Comments on Final Design (FD) Plan Review for Pearl Harbor Station: Review period from to November 5, 2013 to December 5, 2013

Navy	PA Consulting Party Review Comments FD Plans for Pearl Harbor Station	Reviewer: S. Wachi, Deputy JB4 (Joint Base Pearl Harbor-Hickam) via letter s by Captain J.W. James - to HART December 5, 2013

FD review plans, pages 10 and 26

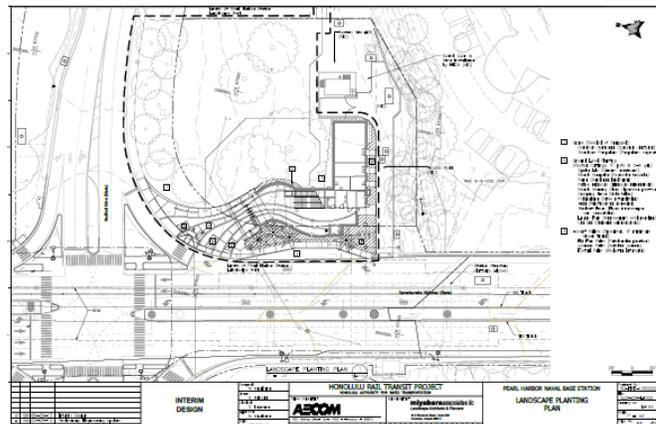
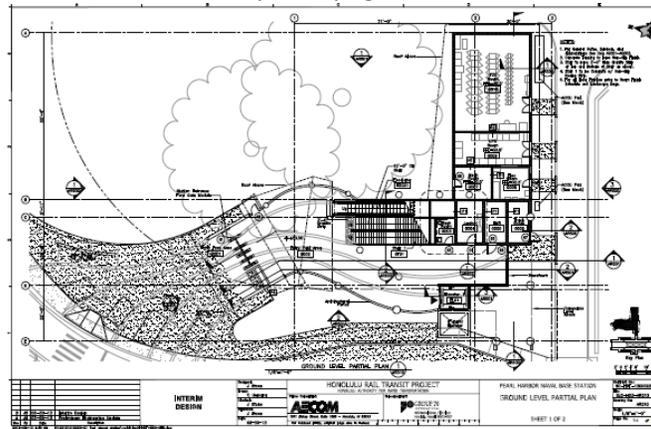
- 8. HHF is concerned with the impact of the utility building, and notes that this use expands the footprint of the facility and adds bulk, mass and heaviness to the overall design and extends into the park-like setting.
- 9. HHF recommends that HART evaluate if this utility building has to be located at this station or whether it can be moved to a different station.

<p>10. If the utility building needs to be sited at this location, the mass and size need to be minimized. Changes in material and overall bulk will be needed to lessen its massive appearance.</p> <p>11. How will workers access the utility area for maintenance? Are you proposing a driveway? Any additional asphalt, curb cuts or vehicular use will undermine the park setting.</p> <p>12. Is the proposed utility area on a slope? If so, the building may be able to use a cut and fill with a berm covering parts of the walls so the building doesn't seem so tall, massive and overwhelming.</p>	<p>10. Location & Size of TCCR: As stated in No. 8 above, the TCCR is located due to technical requirements of the train system. The height and floor area is optimized for the equipment housed therein. This facility, as with all HART station facilities, is minimal area required for technical and operational efficiency and is precisely the space required by the specific function.</p> <p>11. Maintenance Drive: The station facilities require access for maintenance and service vehicles, so it is proposed that a maintenance driveway will be located at this site.</p> <p>12. Site Grading: The TCCR is located on a flat portion of the site. Finished floor elevation is at 29.50 and adjacent grade is at 29.0. Significant cut and fill is not required.</p>

HART acknowledges the comment on facilities bulk, mass and heaviness on the setting of this site. This is something can be further explored during the design process.

8. Utility Bldg: The Train Control & Communications Room (TCCR) and supporting UPS, A/C and Electrical Room is a requirement of the train operating system and is located at all stations.

9. Location of Utility Bldg: The TCCR is positioned to allow electrical and communications wiring and associated conduit to connect to the station entry, the concourse and the boarding platform and must be in close proximity to these spaces and facilities.

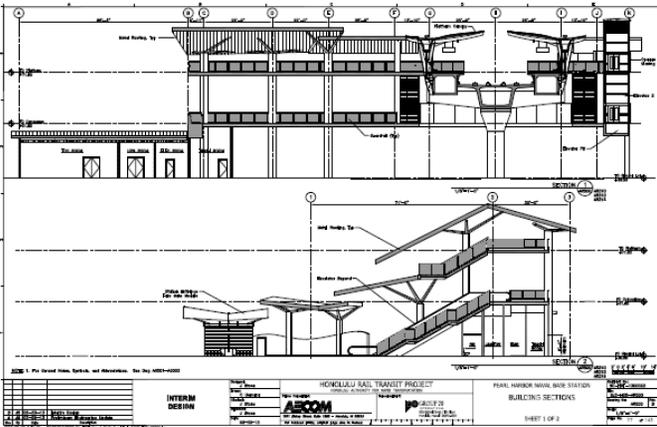
<p>15</p>	<p>Consolidate Spaces</p>	<p style="text-align: center;">FD review plans, page 18</p>  <p>15. HHF recommends that HART evaluate how to merge some of the spaces, like the janitor room, under staircases to consolidate spaces and make a smaller footprint.</p>	<p>15. Consolidate Spaces: As shown on the building section at left, the Rest Room, Janitors Room, Elevator Machine Room and Trash Room are under the stairs and landing to minimize the entry structure footprint.</p>

FD review plans pages 16 and 21

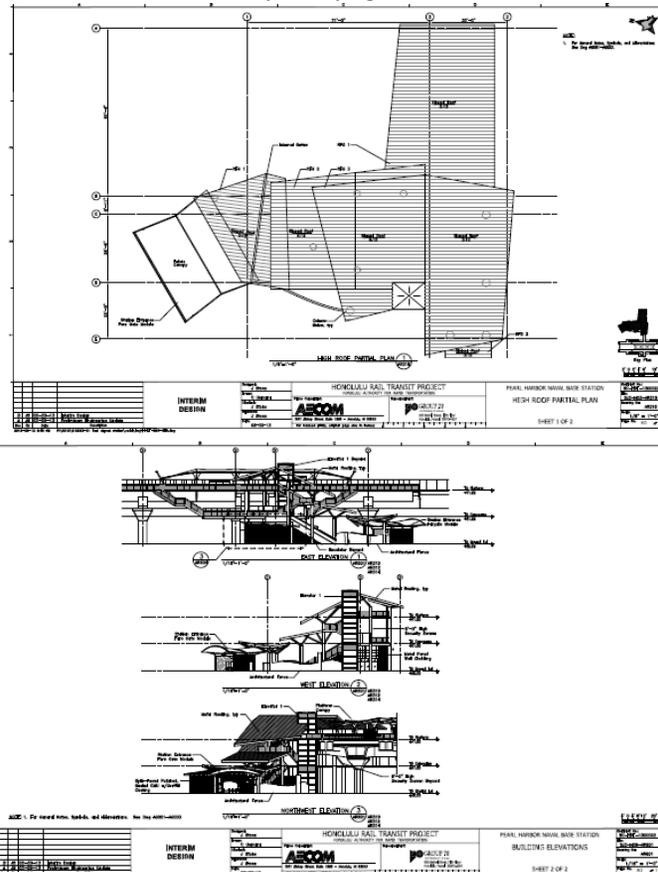
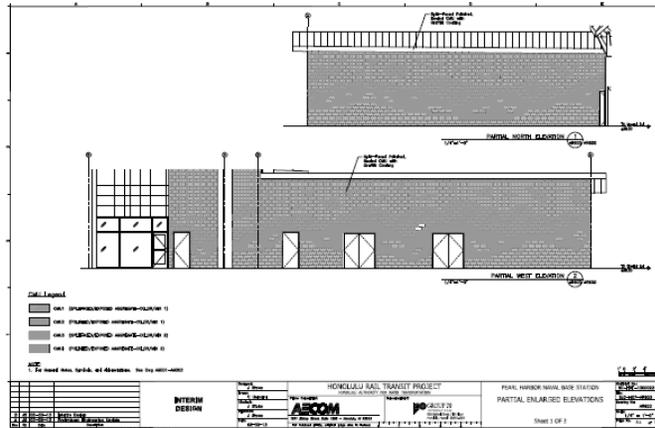
16. Plan notes indicate “RFG1,” “RFG 2” and “RFG3” but do not have explanations. Do these indicate different roofing materials?

17. The roofs should be simple and reflect the historic residential area. The design is too busy with the different angles and curved roof.

18. The roofs should be simplified to better reflect the calm, natural feeling of the park and historic residential area. This could potentially be achieved through using the same pitch and same material on all rooflines.

16. Roofing Materials: RFG 1 through RFG 3 are standing seam metal roofing. These roofs are the same material.

17. Roof Configuration: The entry structure roof configuration was inspired by the adjacent Makalapa residential housing roofs, with various pitched, hips and sizes. The juxtaposition of the roofs, with supporting columns, are tree-like in character, a reflection of the adjacent tress and park-like setting. This design is a significant departure from previous roof configuration with a unified roof line. A unified roof does not address the vertical circulation configuration and resulted in a taller and more massive structure, as shown on the earlier preliminary drawing, see Attachment 3.

18. Roof: Refer to No. 17 above.

FD review plans, page 22

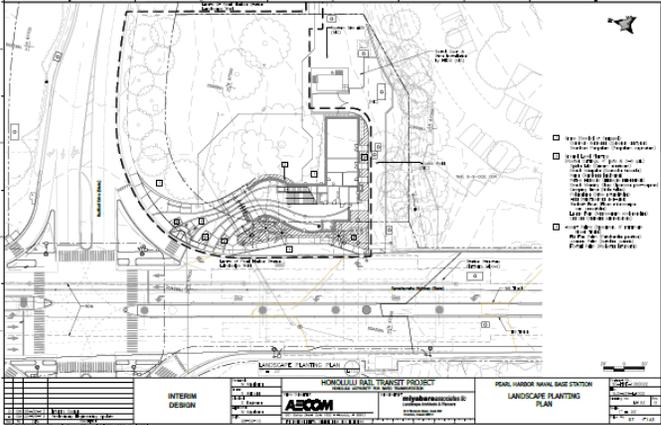
19. Plan notes indicate CMU 1,2,3,4: Are these different CMU materials? Are you trying to show a pattern/design? The drawings do not clearly depict the intent. Please explain.

19. CMU (Concrete Masonry Units) Materials: The CMU materials, as indicated on the CMU Legend at the lower left of the drawing, are a combination of textured and integral color concrete block. The various colors, textures and finishes were inspired by the earth tones of the stone retaining walls, the massive tree trunks, variegated leaf and shadow pattern and the setting of the station location.
